Intersection ID: 13611	Main Street: E_MOREHEAD_ST	Cross Street: EUCLID_AV	Location:	NW
ADA ID: 4AD907CE07FA	Ramp Type: PerpDiag	Initial Pass/Fail: Fail	Overall Compliance: No	Severity Score: 26.25

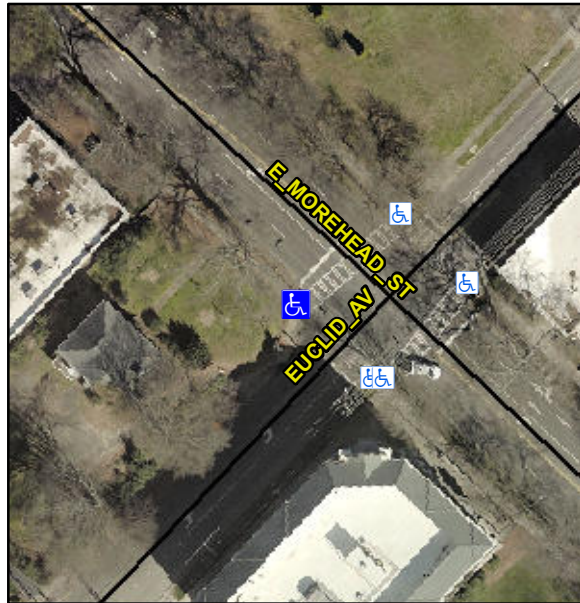
**Not Found, R304.2.2, R304.5.3**

Compliance	Description	Data	Compliance	Description	Data
N/A	Ramp Length (in)	57.0	No	Ramp Slope (%)	12.6
Yes	Ramp Width (in)	48.0	No	Ramp XSlope (%)	3.8
N/A	Flare Type LT	N/A	N/A	Flare Type RT	N/A
N/A	Flare Slope LT (%)	N/A	N/A	Flare Slope RT (%)	N/A
N/A	Flare Traversable LT?	N/A	N/A	Flare Traversable RT?	N/A
N/A	Landing Length (in)	N/A	N/A	DWS Provided?	N/A
N/A	Landing Width (in)	N/A	N/A	DWS Contrast?	N/A
N/A	Landing Slope (%)	N/A	N/A	DWS Length (in)	N/A
N/A	Landing X Slope (%)	N/A	N/A	DWS Full Width?	N/A
N/A	Landing Curb? (Y/N)	N/A	N/A	DWS Offset (in)	N/A
N/A	Shared Landing?	N/A			
N/A	Gutter Ponding?	N/A	N/A	Gutter Slope (%)	N/A
N/A	Gutter Lip Ht (in)	N/A	N/A	Gutter X Slope (%)	N/A
N/A	Painted X Walk1?	Yes	N/A	Painted X Walk2?	Yes
	X Walk 1 Direction	To SE		X Walk 2 Direction	To NE
N/A	X Walk 1 Width (in)	108.0	N/A	X Walk 2 Width (in)	104.0
	X Walk 1 Slope (%)	0.2		X Walk 2 Slope (%)	3.6
	X Walk 1 X Slope (%)	0.2		X Walk 2 X Slope (%)	1.2

**Remove & Replace Curb Ramp With Two New Directional Ramps or Equivalent.**
